12525 Saratoga Creek Drive
Saratoga, CA 95070

April 2, 1980

Dr. J. Hendrie
USNRC
Washington, D.C. 20555

I believe the attached curve on peak temperature from SECY-80-107 (Figure 4) is erroneous even though this has little bearing on hydrogen production and implications. However, the umbrella of conservatism should not be an umbrella for acceptance of fundamental errors. Specifically, the curve implies a peak temperature that is limited by the amount of Zircaloy reacting; and that a solid Zircaloy rod would reach a substantially higher temperature. Of course, the thermodynamics of the process has been ignored in this analysis. (over)

FIGURE 4 FUEL CLAD TEMPERATURE RESPONSE

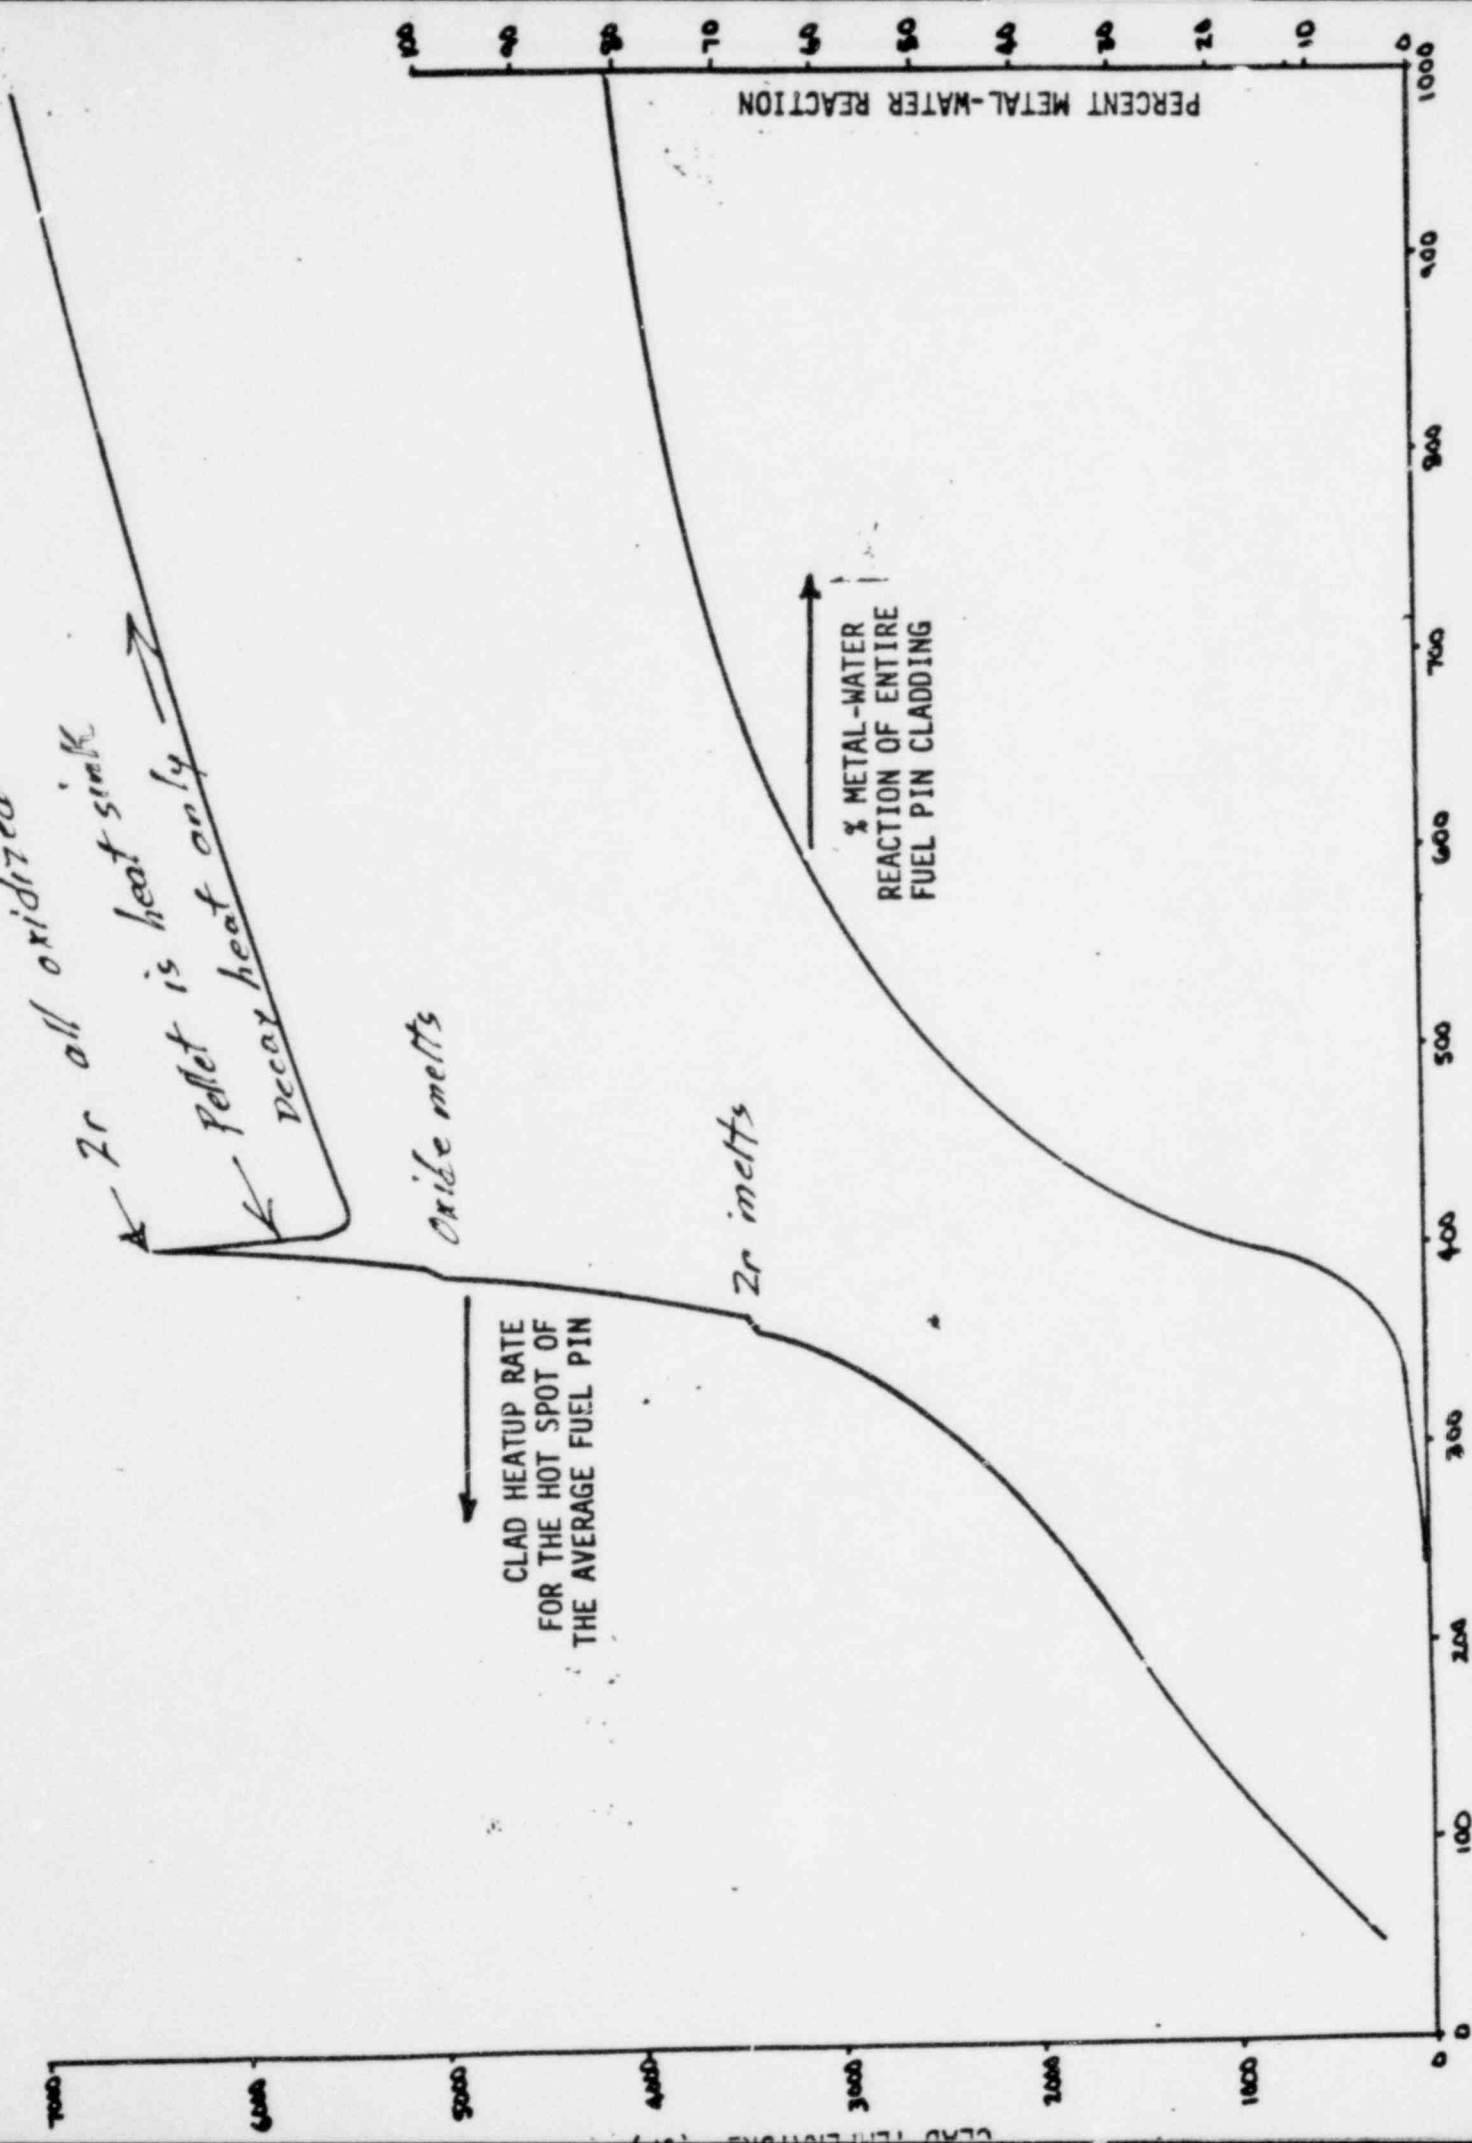
I would highly appreciate having your expert staff report the following calculations to me at their convenience.

What is the maximum flame temperature for the following reactions assuming no excess reactants?

I think case A is independent of pressure, but case B may be pressure dependent. I'd like to see results for 1, 10, 100, and 150 atm. but I'm not particular.
